Hillside Mining Lease Proposal Response Nov 2013

Mr Mark Howe
DIMITRE
GPO box 1671
Adelaide 5001

I am a Landowner in the vicinity of the proposed Rex mine.

Figure 9.2: Predicted maximum 24-hour PM₁₀ Concentration (Mine Operations) – including background concentration, App 5.6 C

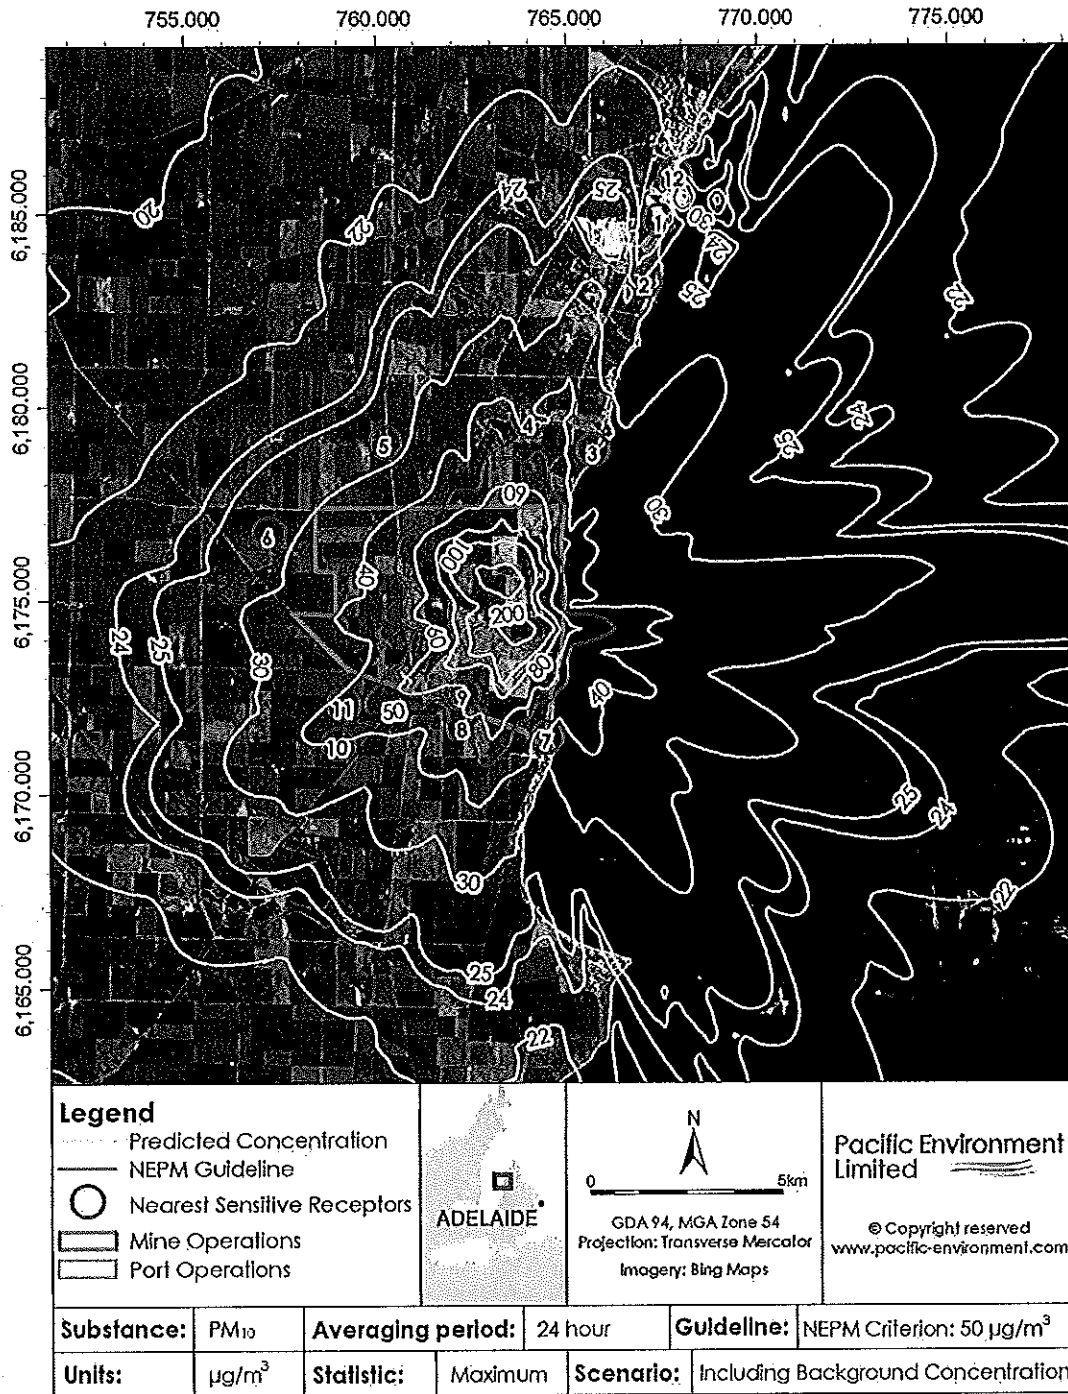
Land adjacent to the mine will receive dust from the mining and road relocation operations. This will affect farming land within a large radius on the mining activities. Referring to the chart below, a significant portion of the surrounding farmland is predicted to exceed the National Environment Protection Measure (NEPM) 24 hr criterion for PM10 of 50 micrograms per cubic metre. Refer figure 9.2 below.

- Provide further detail on the proposed dust suppression methods, as the current plans are shallow and ineffective.
- Provide detail on dust impact on health of the local population

Figure 8: Location of groundwater investigation wells (App 5B, Groundwater Injection Disposal Modelling, pg 13)

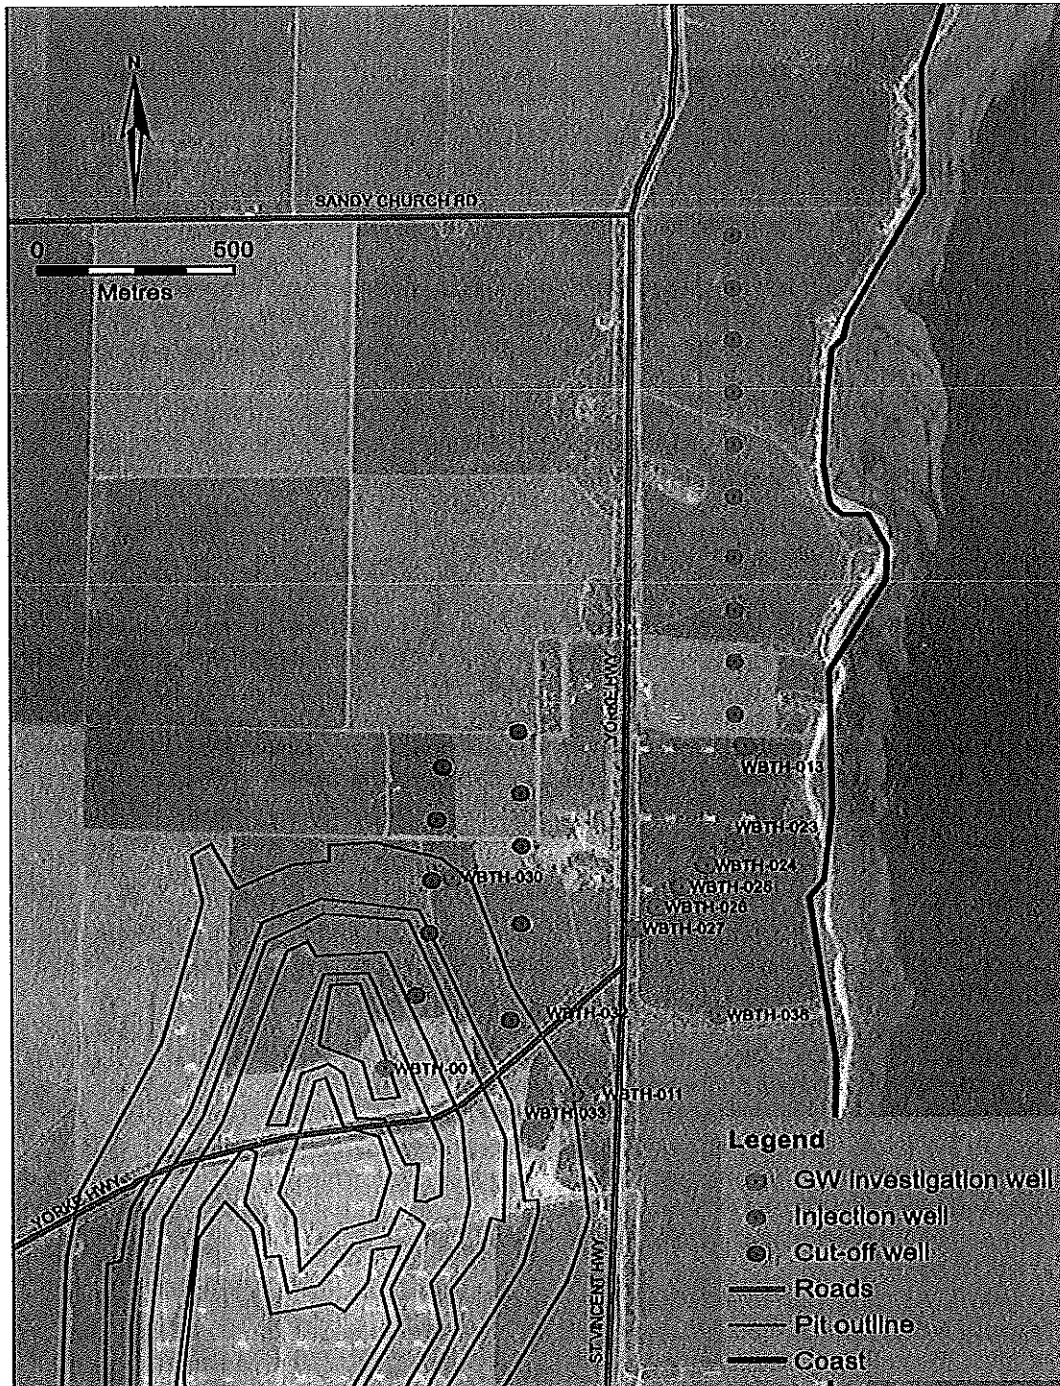
As it appears that the reinjection borefield is planned to run through the centre of coastal property (refer figure 8 below, app 5B pg) this will have a significant impact on cropping activities and will reduce available arable land due to the bores, buried pipelines, associated equipment and access tracks.

The capabilities of the injection borefield appear to be based on the performance of 1 well only, WBTH 013 which is bored into the coastal granite on the north eastern side of the proposed pit. Modelling an injection Borefield utilising the data from only 1 well does not lend itself to accurate outputs from the model.

- Explain how they can construct a 2.2 hectare visitor centre on the eastern side of Yorke Highway, contravening Coastal Land zone regulations.
- How they can plan a borefield based on the performance of only 1 well.
- Explain why the visitor centre placement is not shown on the mining lease proposal

Figure 5: Modelled discharges, revised layer 3 Kh, layer 4 Kh = 0.1 revised layer 3 Kh

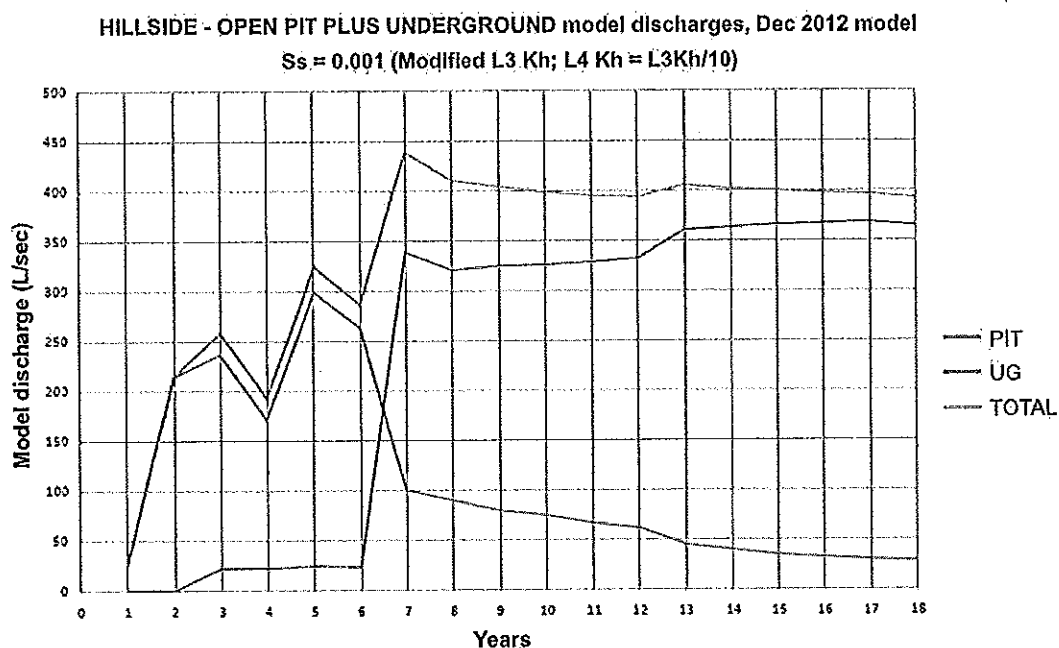
Water use by the mines 2 dust suppression trucks is estimated to utilise up to 1960 M3/d, however this still leaves from 12700 to 36000 M3 per day to be disposed of. As evaporation has only a minor impact, there will be significant water volumes to dispose of.

The holding pond size is not mentioned, but the 100 ML tails dam seepage storage pond area is, this would only take between 3 to 8 days to fill based on the above figures. The only other

It appears that water control will be technically and environmentally challenging for Rex and also very expensive – given the cost of moving up to 38 megalitres of water per day. Water handling may well make the Rex Project economically unviable.

- Explain how they will handle the significant volumes of water that the mining operations will produce – will they pump it into Gulf St Vincent.
- Explain why they only commissioned water drilling test holes to 200 metres when mining operations were planned down to 700 metres.
